<b>REPORT TO</b>	Statutory Planning Committee		
<b>Meeting date</b>	20 November 2018	<b>File number</b>	156906
<b>Subject</b>	Subdivision to Create 1,940 Lots and 17 Reserves - Various Lots Barragoon Road, Caraban, Moore River South		
<b>Purpose</b>	Requires WAPC decision		
<b>Title of Approving Officer</b>	A/Assistant Director General, Land Use Planning		
<b>Agenda Part for Reports</b> SPC - Non-Confidential (To be published to the website)			
<b>SITE-SPECIFIC DETAILS</b>			
<b>Region/s</b>	Wheatbelt		
<b>Local government/s</b>	Shire of Gingin		
<b>Landowner: Consultant:</b>	Moore River Company Pty Ltd - Marcus Plunkett & Graeme Sampson Creative Design + Planning - Denise Morgan & Chee Mok		
<b>Location map</b>	Attachment 1 - Locality plan		
<b>Bushfire Prone Area</b>	YES		
<b>Statutory Planning Committee</b>			
<b>Local Scheme Zoning</b>	Future Development and General Rural		
<b>Council's recommendations</b>	Approve subject to conditions

<b>Receipt date</b>	29 June 2018	<b>Process days</b>	144 (with deferral)
<b>Property Address</b>	Lots 2593, 3156, 2802, 2914, 2424 and 3099 Barragoon Road, Caraban		
<b>SUMMARY</b>			
<p>The application proposes the subdivision of Lots 2424, 291

Foreshore Reserve

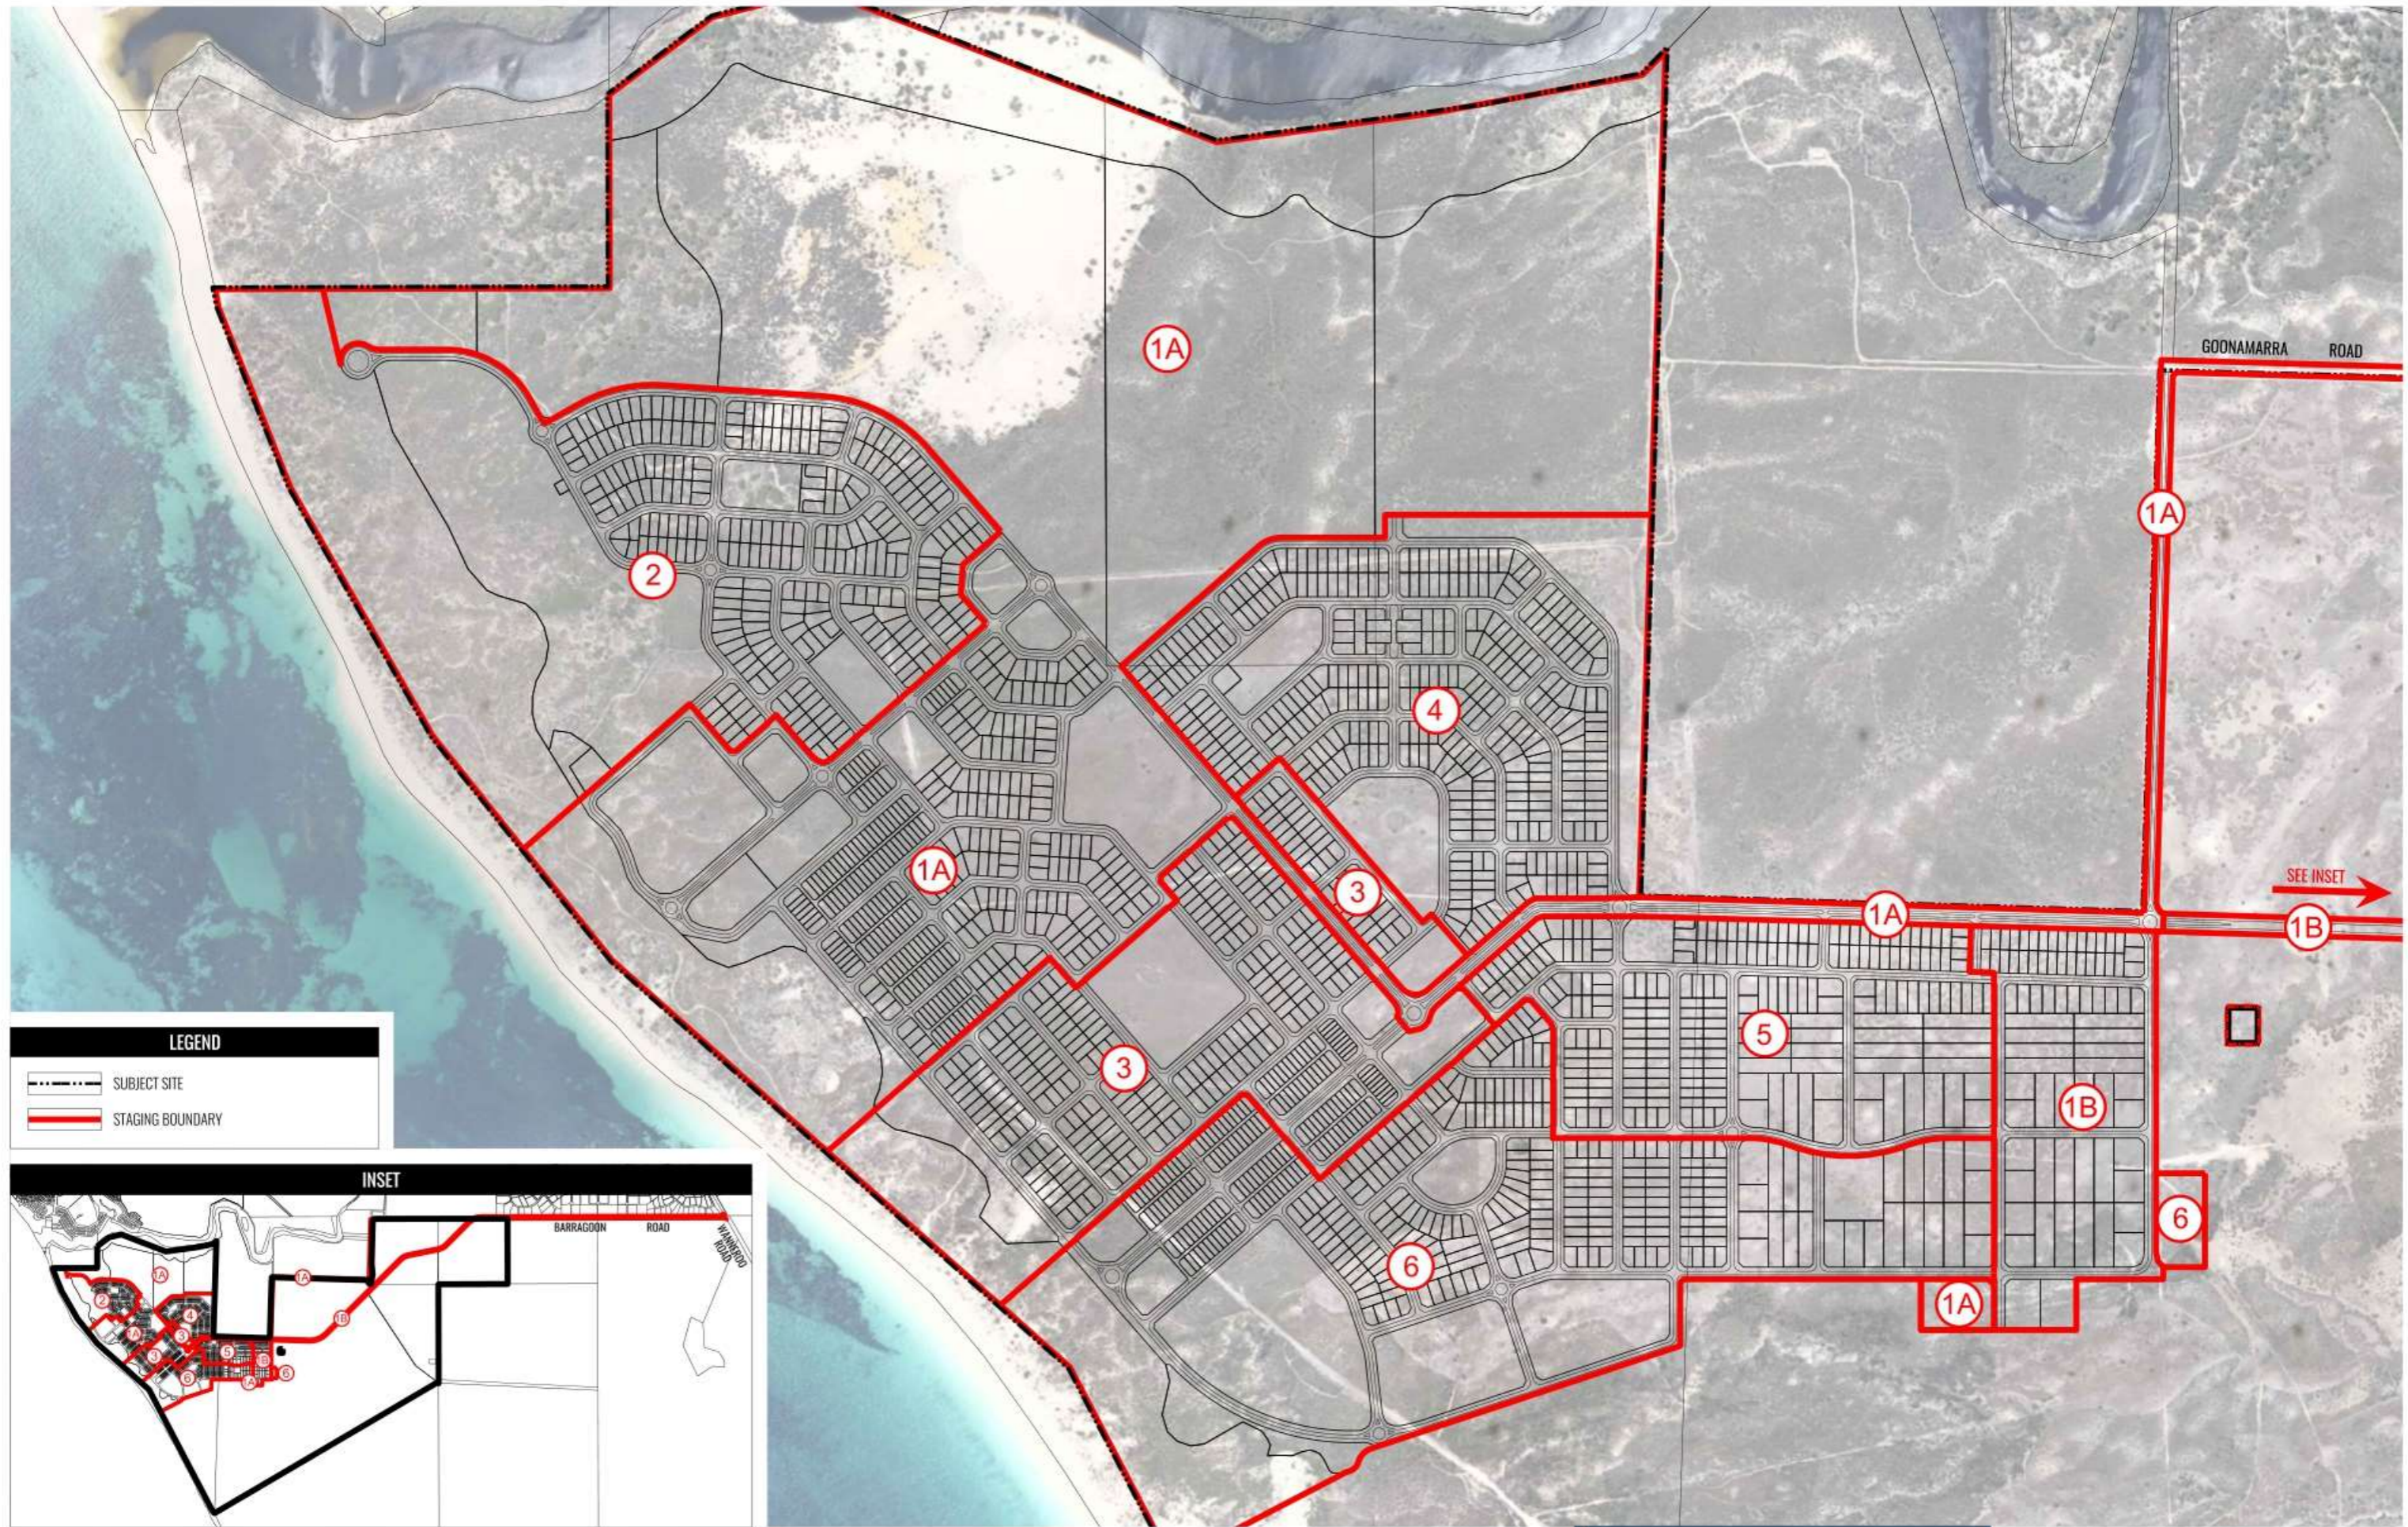
The foreshore reserve identified on the original plan of subdivision only provided for the required physical process setback. In order to achieve consistency with SPP 2.6, the Department has negotiated an increase in the width of the coastal foreshore reserve by approximately 30-150m along its length. This has increased the area of the coastal foreshore reserve from 25.8ha to 43.2ha and is shown in **Attachment 5 - Foreshore Reserve**.

This modified plan is consistent with the objectives and intent of SPP 2.6, as the reserve has taken into account the necessary elements, responds to the site's physical attributes and is of a sufficient size to accommodate land uses associated with public use of the coast. **Attachment 5 - Foreshore Reserve** illustrates the difference between the original plan of subdivision and the modified plan recommended for approval. The recommended approval of this type of coastal foreshore reserve is relevant to other upcoming coastal proposals, such as structure plans for Alkimos and Burns Beach, where the WAPC will be requested to make similar decisions in regard to implementation of SPP 2.6.

The existing Foreshore Management Plan sets out the ongoing management of the foreshore reserve and outlines a less generous foreshore reserve than the modified plan of subdivision. As a result, a condition is recommended to update the Foreshore Management Plan as necessary to implement management measures, including those which identify and protect biodiversity values.

- 29. Uniform fencing being constructed along the boundaries of the proposed lots abutting public open space. (Local Government)**
- 30. The proposed foreshore reserves shown on the approved plan of subdivision being shown on the diagram or plan of survey (deposited plan) as a reserve for foreshore management and vested in the Crown under Section 152 of the Planning and Development Act 2005, such land to be ceded free of cost and without any payment of compensation by the Crown. (Local Government)**

- 31. Prior to the commencement of subdivisional works the Moore River South Foreshore Management Plan by Cardno (Version 5, dated 17 September 2014) is to be updated, approved and satisfactory arrangements being made for the implementation, including any works and associated cost, of the approved plan by the landowner/applicant to the specification of the local government and satisfaction of the Western Australian Planning Commission. (Local Government)**
